# 2011-10-09

## CESSNA AIRCRAFT COMPANY

Amendment 39-16690

**Airworthiness Directives; Cessna Aircraft Company Models 150, 152, 170, 172, 175, 177, 180, 182, 185, 188, 190, 195, 206, 207, 210, T303, 336, and 337 Airplanes**

Figure 1. Diameter of seat pin locking engagement hole

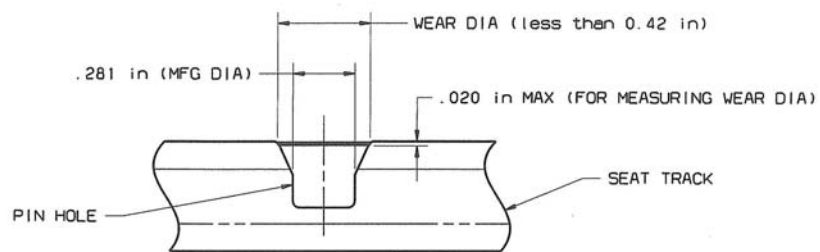
Dave McFarlane requested we add a maximum allowable incremental 0.07-inch radius dimension to figure 1 at the outside diameter dimensions for clarification.

We disagree with this comment. The measurement dimensions in figure 1 adequately address the measurements necessary for this AD. Additional measurements will not provide any additional benefit.

Figure 4. Closeup of seat roller housing and tang gap width

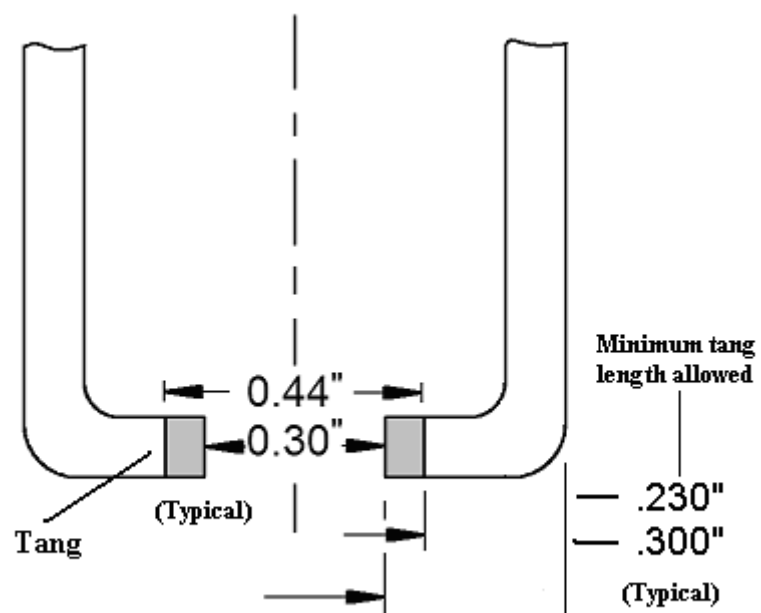
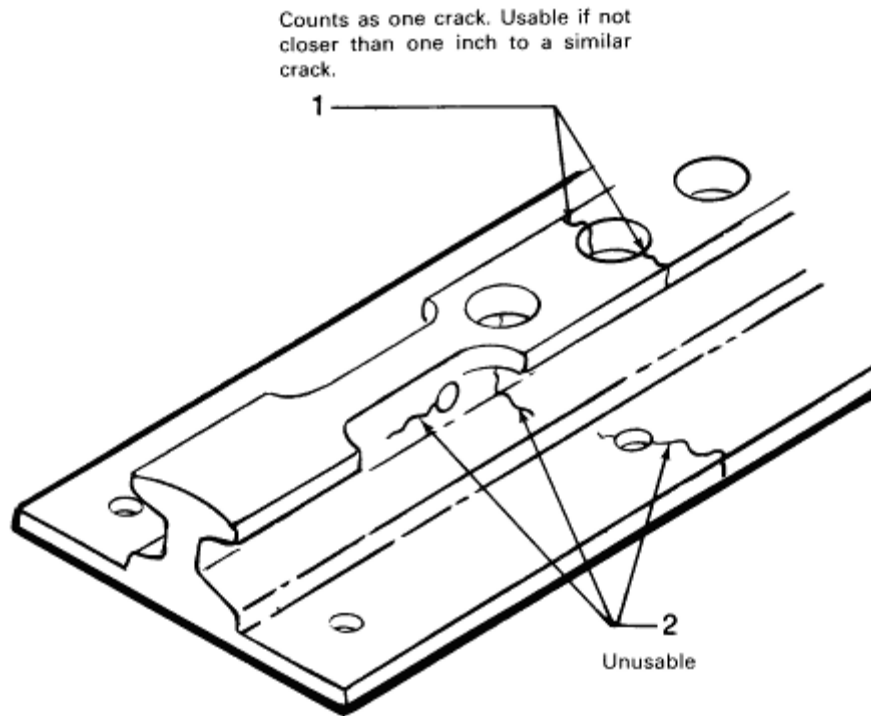
Brian A. Andrus, Jim Currie, and Jerry Unruh requested we change the tang measurement to the outside of the seat roller housing and change the description of the tang measurement. This change would make it easier for the inspector to take the measurement and to better understand what is being measured.

We agree with this comment. We agree that measuring the tang length inside of the roller housing is difficult because of the presence of the rollers inside of the roller housing.

We have changed the callouts in figure 4 to measure the tang length from outside of the roller housing instead of from inside of the roller housing. We have also changed the description of the tang measurement in figure 4 to more accurately describe the measurement.
